MAJOR PROJECT ASSESSMENT:
***Royal Agricultural Society, alterations &
additions to the Exhibition Hall,
Sydney Showground Precinct
Sydney Olympic Park
(MP 09_0206)***

Director-General's
Environmental Assessment Report
Section 75I of the
Environmental Planning and Assessment Act 1979
April 2011

Figure 7: Site analysis of the Exhibition Hall and proposed concourse

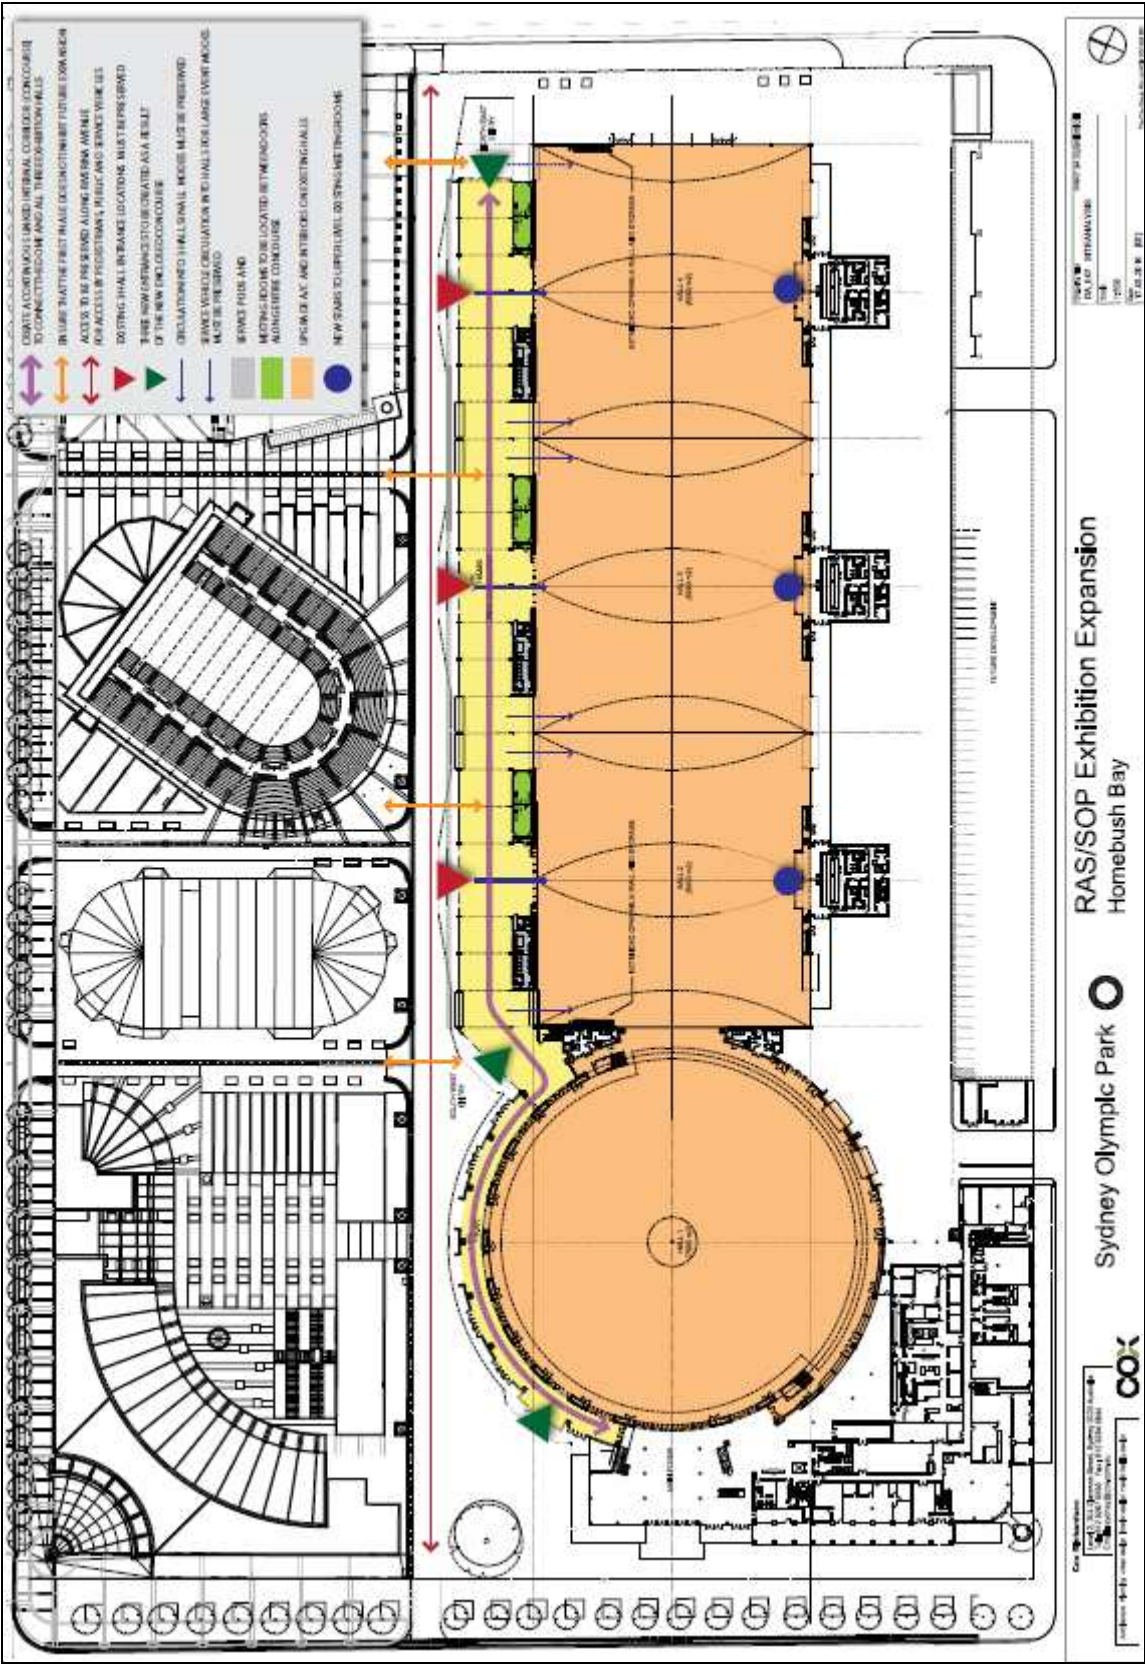
SOPA raised issues in relation to the overall plan in terms of the width of the concourse and doorways to cater for the increase pedestrian circulation, in particular for such events as the Sydney Easter Show. The dimension of the concourse at 208 metres in length, 12.1 metres high and 12.6 metres wide are considered by the proponent to be sufficient to allow for the concourse to be utilised for shelter of people while they wait or queue prior to entering the Exhibition Hall (refer to **Figures 5 and 7**).

SOPA has recommended that a 'Pedestrian Movement Study' be prepared to demonstrate that the concourse and its door widths meet the requirements of the high crowd movements historically experienced at the venue. The Department accepts this view and will incorporate such a condition in the project approval.

Figure 8: The revised ducted work now reduced to six (6).

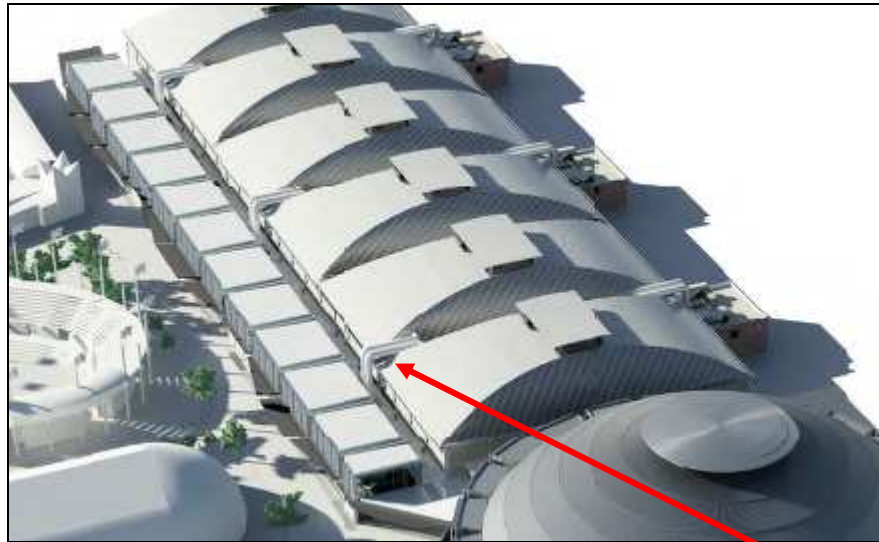
With regards to the proposed duct work, SOPA considered that the twelve (12) duct penetrations to each side of the roof were excessive. This design approach appeared intrusive and visually broke the continuity of the existing eaves line of the building. This prompted SOPA to request a mechanical ventilation report detailing the extent of the duct work required.

As a result, a report was prepared to review options available to improve the existing air conditioning system. Of the three options investigated, low level displacement, side-blow and overhead systems, the overhead air conditioning system demonstrated the most effective method of distributing air throughout the Exhibition Hall. The proponent via the PPR has now reduced the ducts to each side of the building to six (6) (refer to **Figure 8**).

The Department is satisfied that the reduction of the air-conditioning ducts, will improve the visual appeal of the building, while providing efficient air conditioning for the Exhibition Hall.

Figure 10: Proposed paving and relocation of four (4) Fig trees.

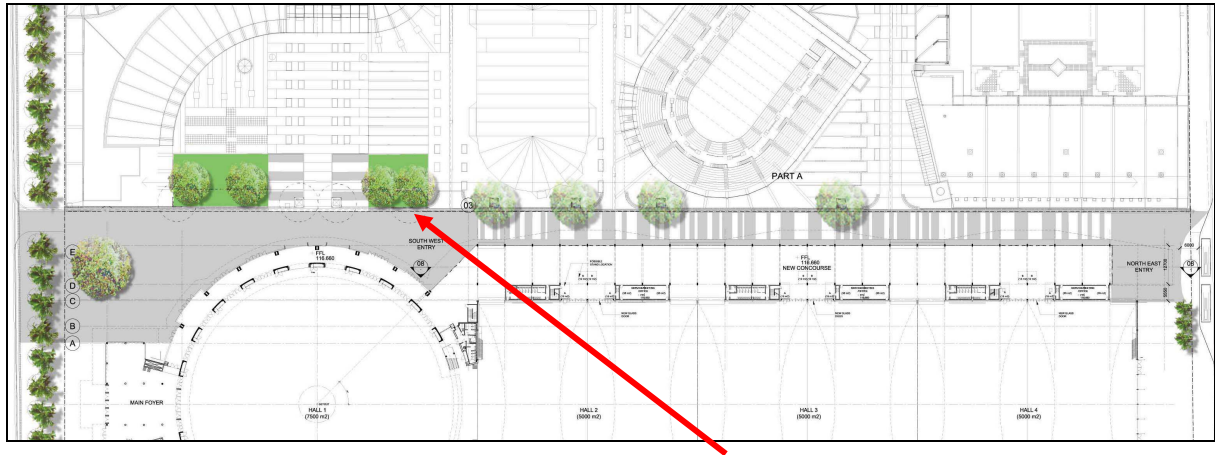
Due to the proposal to resurface Riverina Avenue once the proposed building works are complete, four (4) Fig trees require relocation. The four existing Fig trees will be relocated into the enlarged grassed area which will allow for the widening of the existing path between the RAS Exhibition Hall and the Southee Complex as shown in **Figure 10**.

Two tone concrete paving will be installed in a bar code pattern. The tones of paving used to achieve this pattern are charcoal and quartz which will match with the existing pavement in front of the Southee Complex. In addition to the new paving in Riverina Avenue, the grassed areas in front of the Southee Complex will be extended.

The Department raises no objection to the relocation of the existing Fig trees, as it allows for the existing pavement to be revitalized and is compatible with existing pavement in front of the Southee Complex. To ensure of the longevity of the trees, the Statement of Commitments appropriately addresses the protection of the Fig trees by the preparation of a Tree Projection Plan prior to works commencing.
